# PLANNING BOARD MEETING

c. Project: Site Plan – Dandy Mini Mart – Convenience (Mini) Mart

This is our response to the comments provided on June 10, 2022, for the above-referenced project. The following is an item-by-item response, numbered in accordance with your original comments.

NTS.

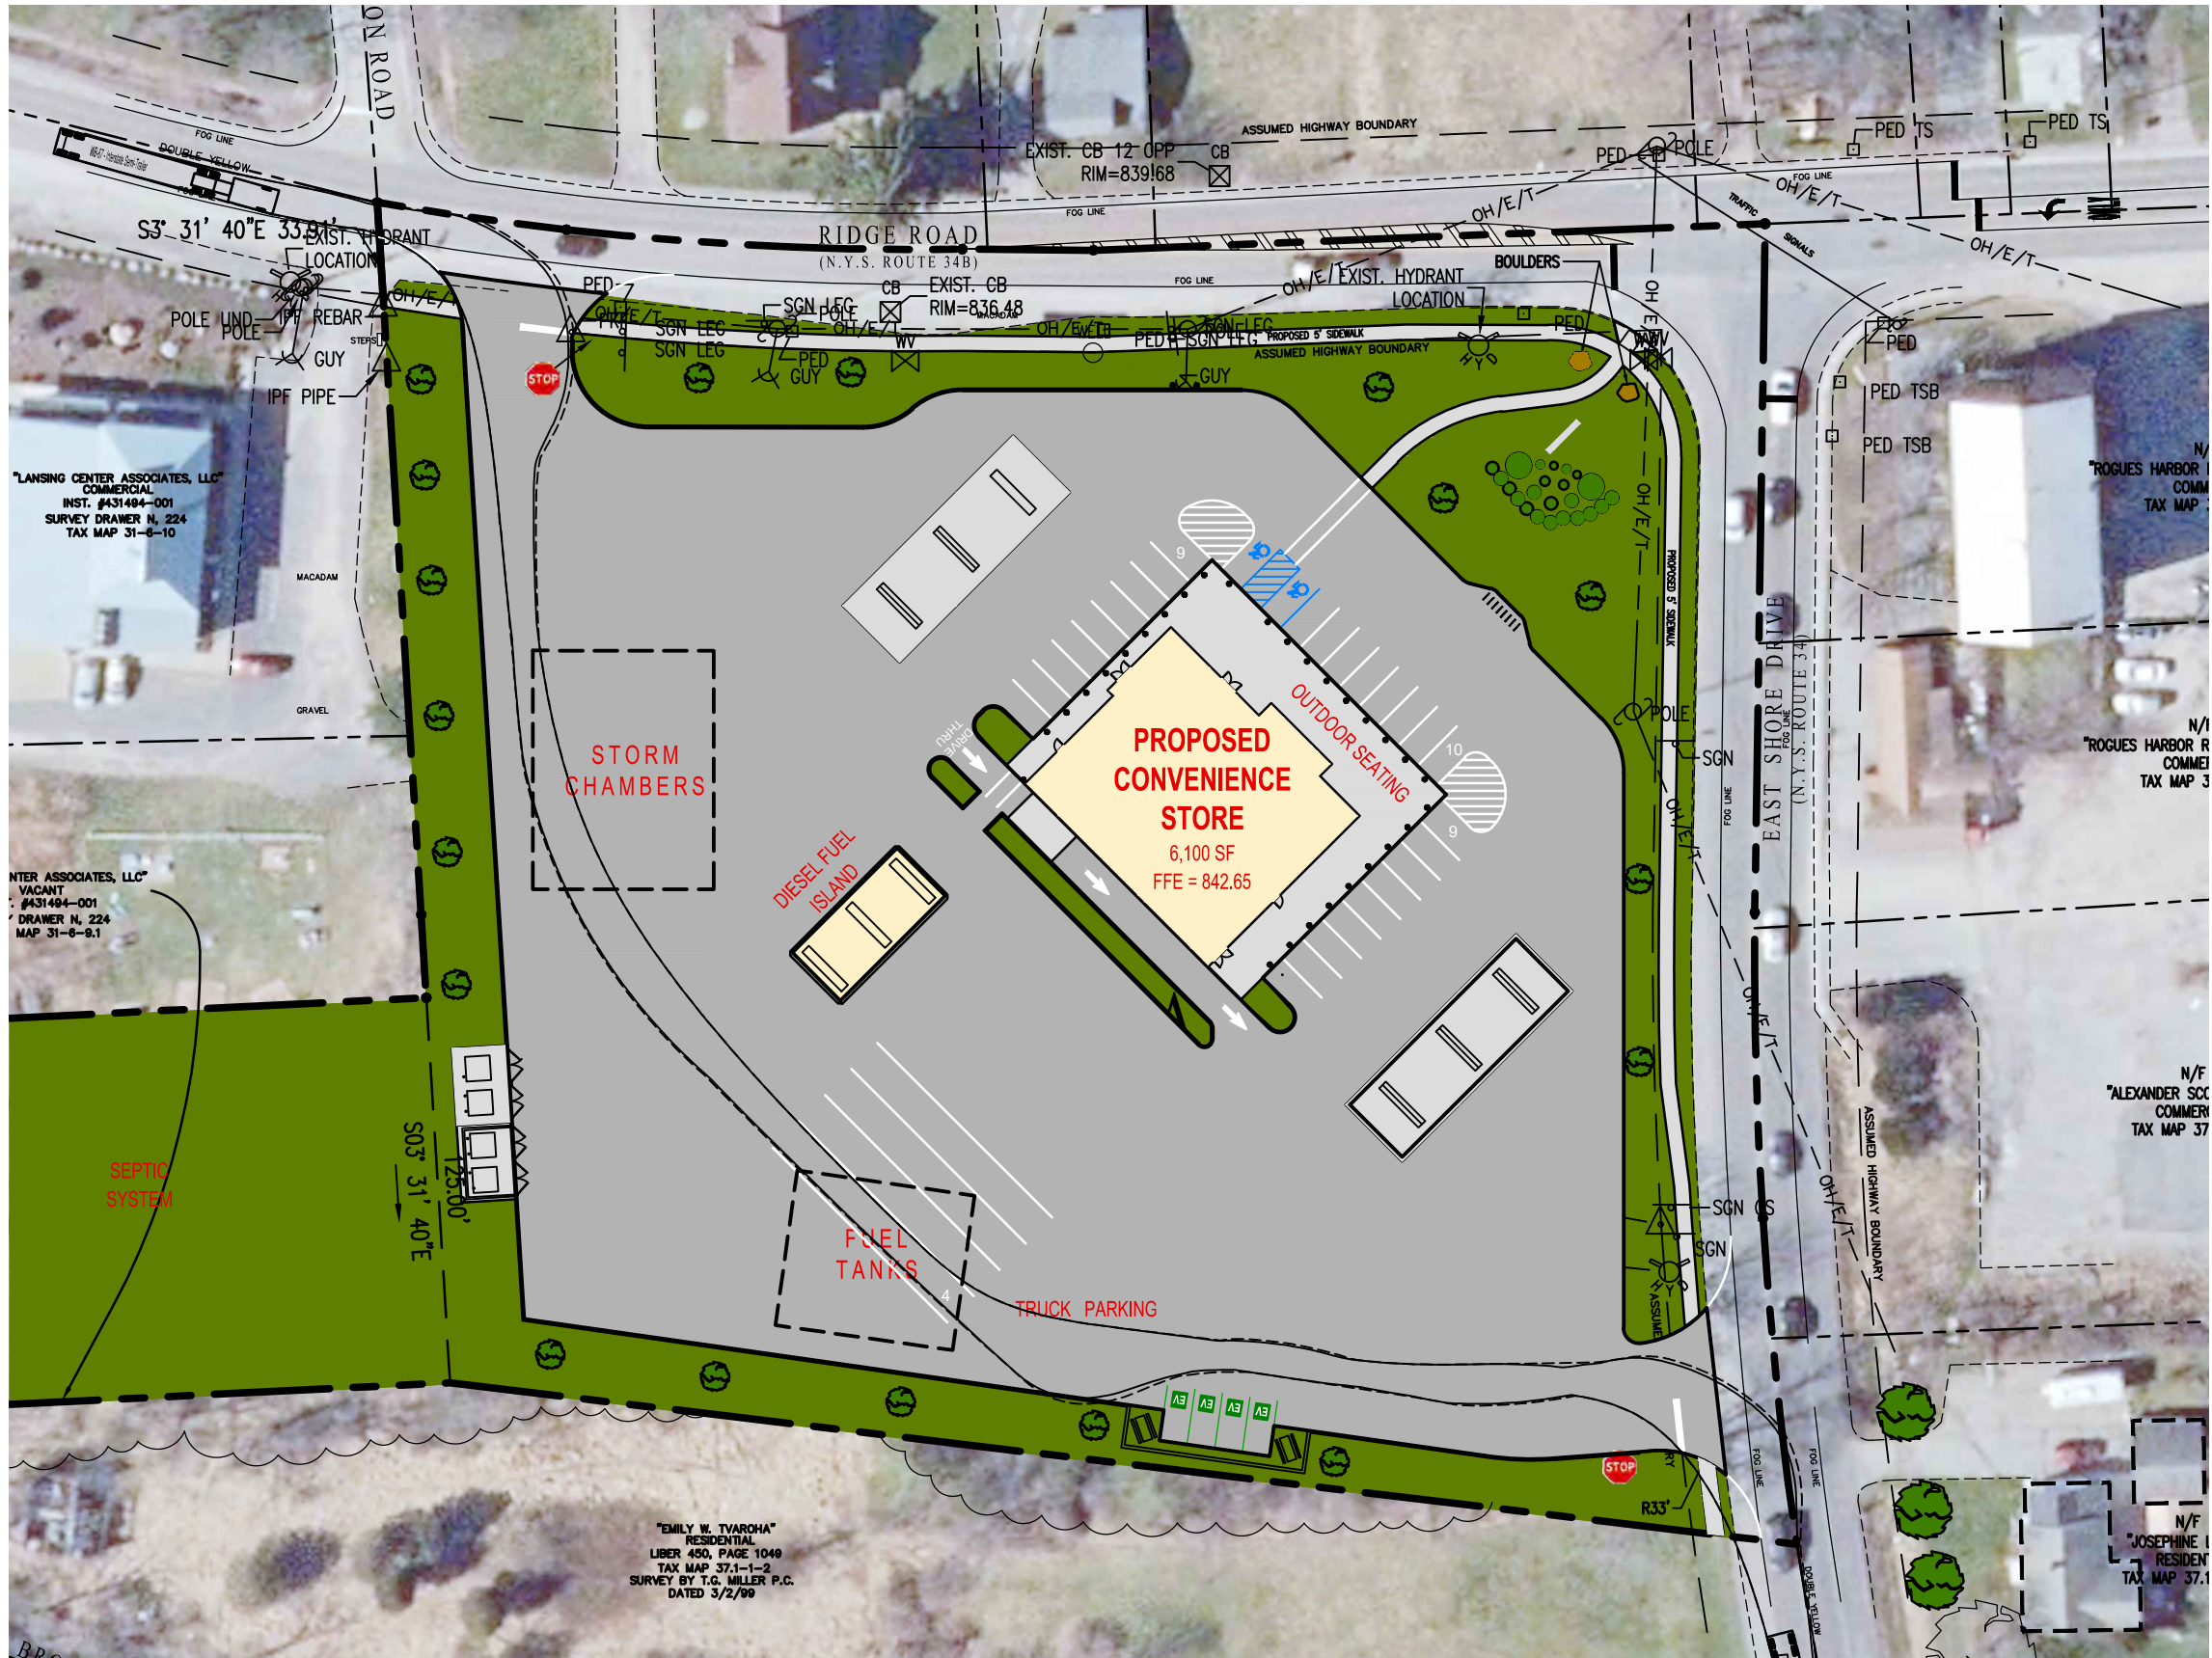
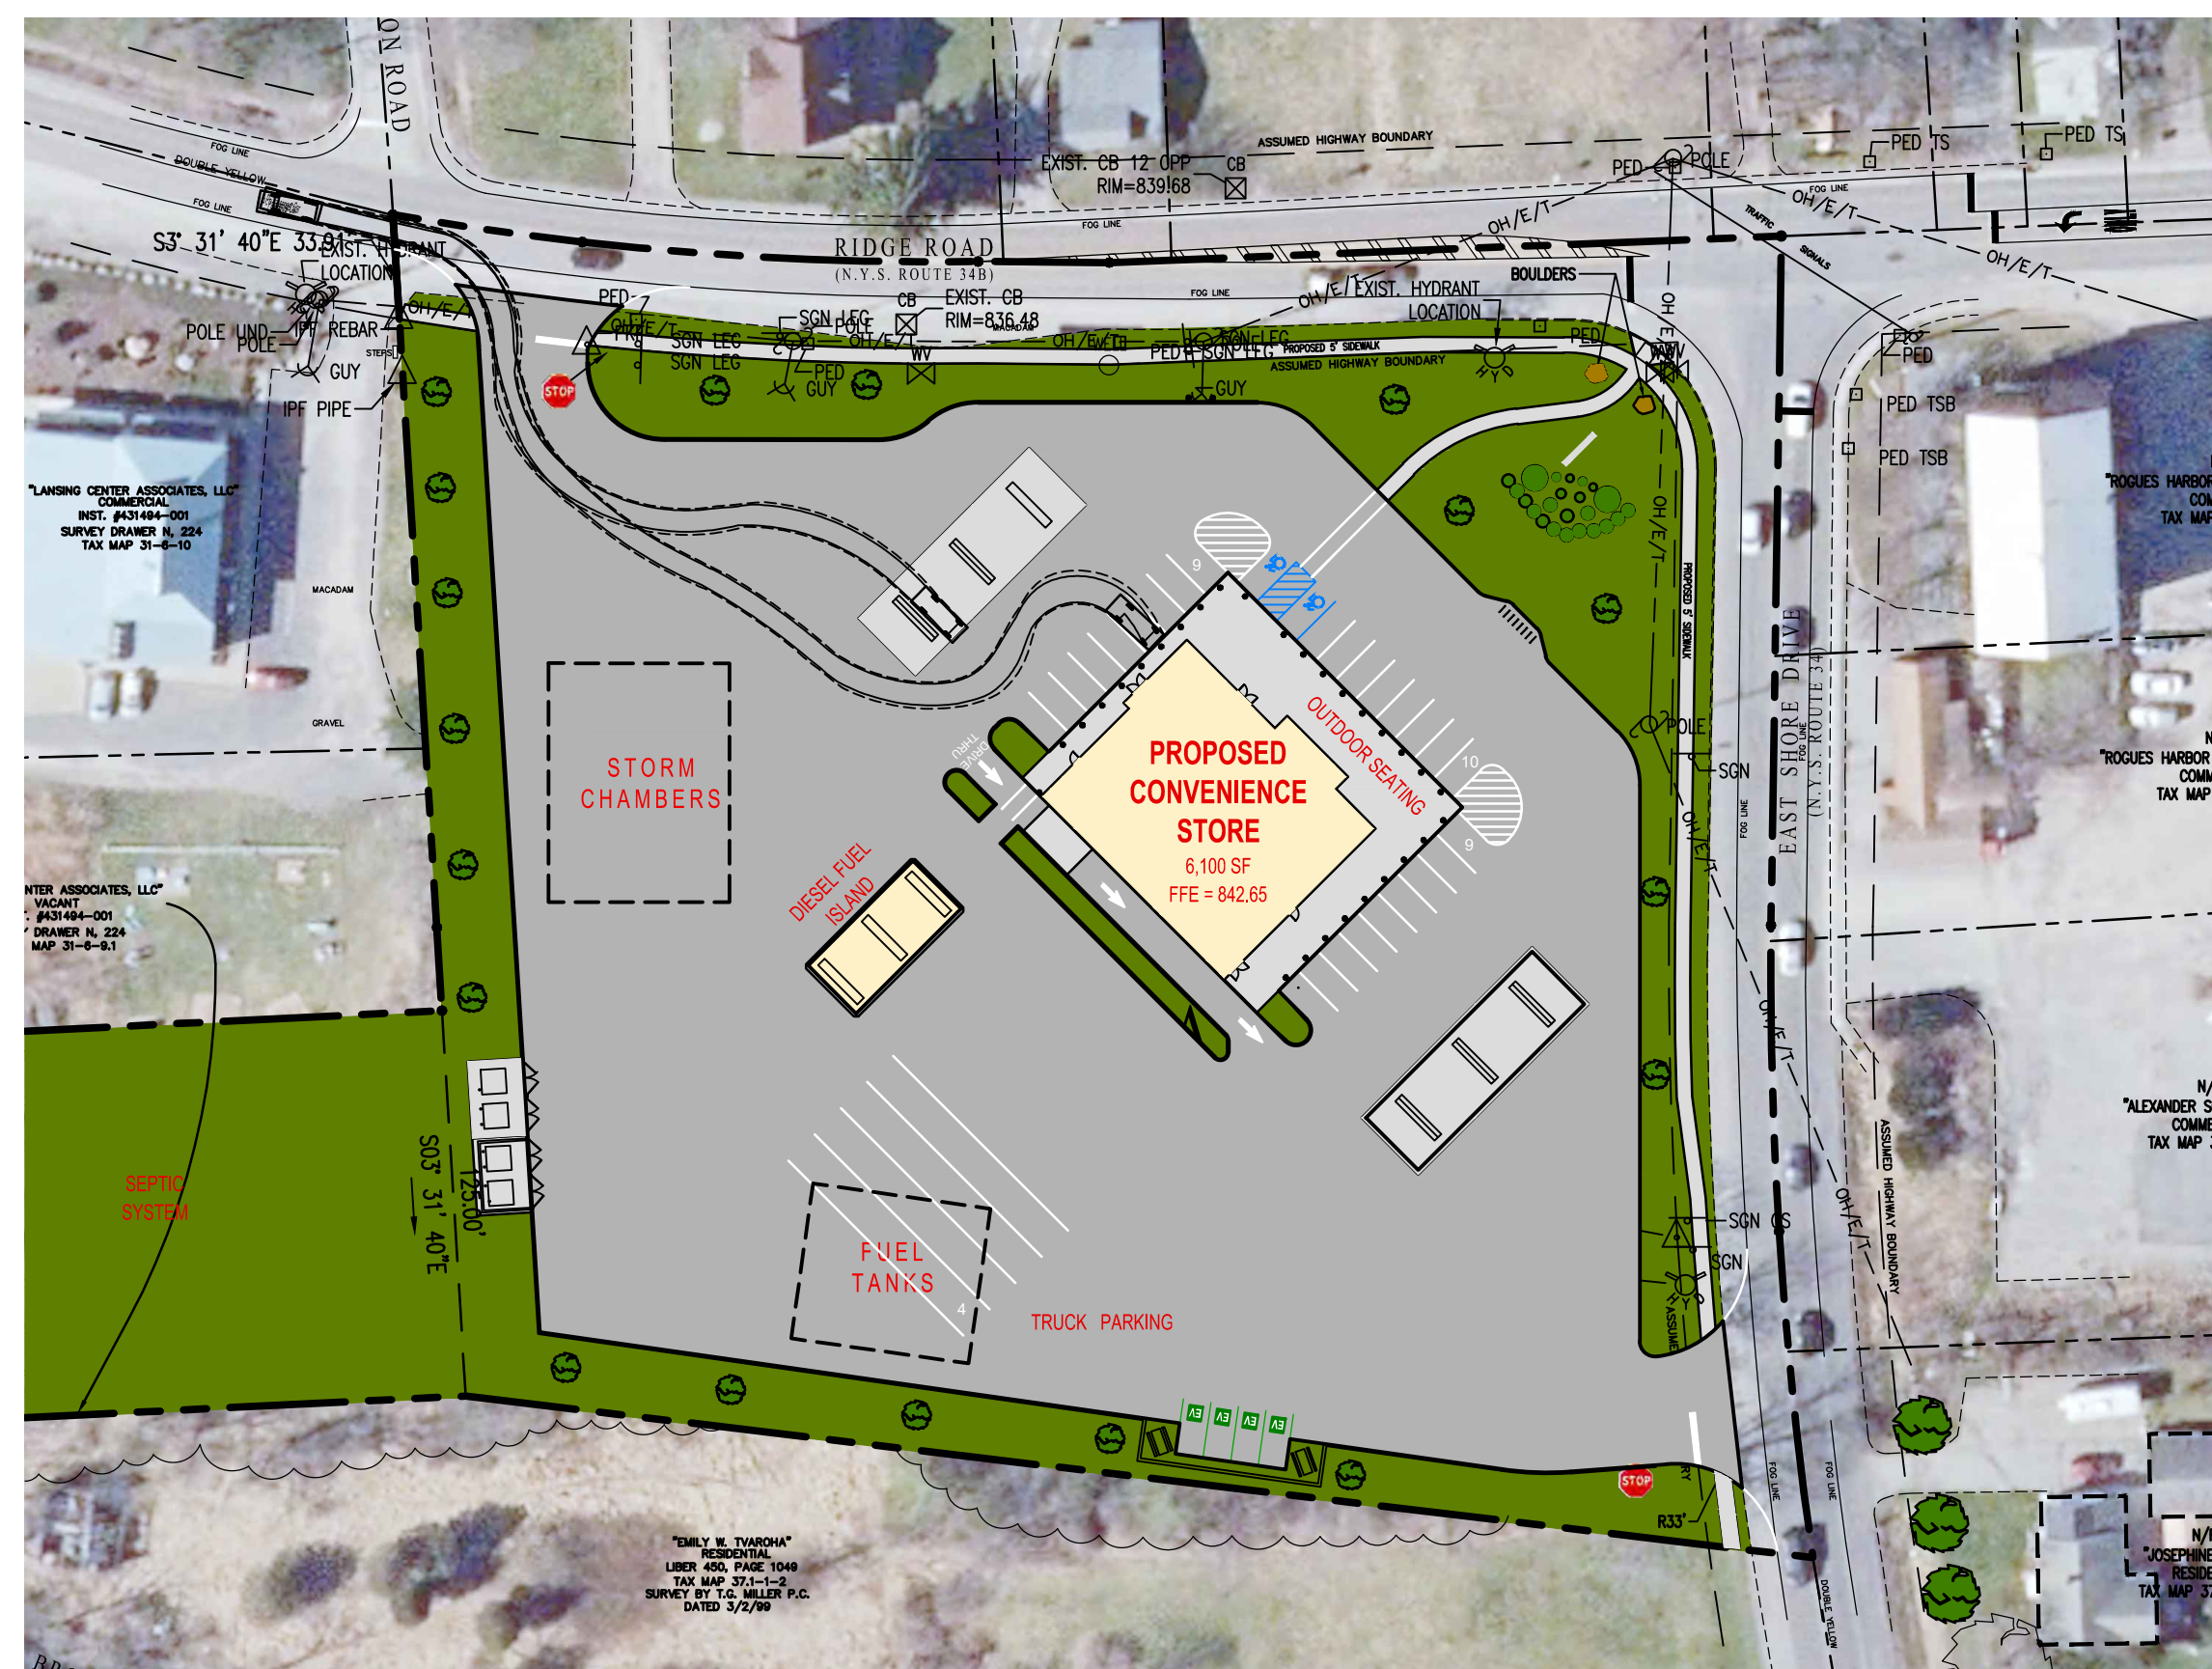
*C5 Sheet C19 is labelled as “truck turning plan”, there do not appear to be any turning movements shown on the plans.*

**R5 Please see revised Plan Sheets C18 and C19 for truck turning and passenger vehicle turning movements.**
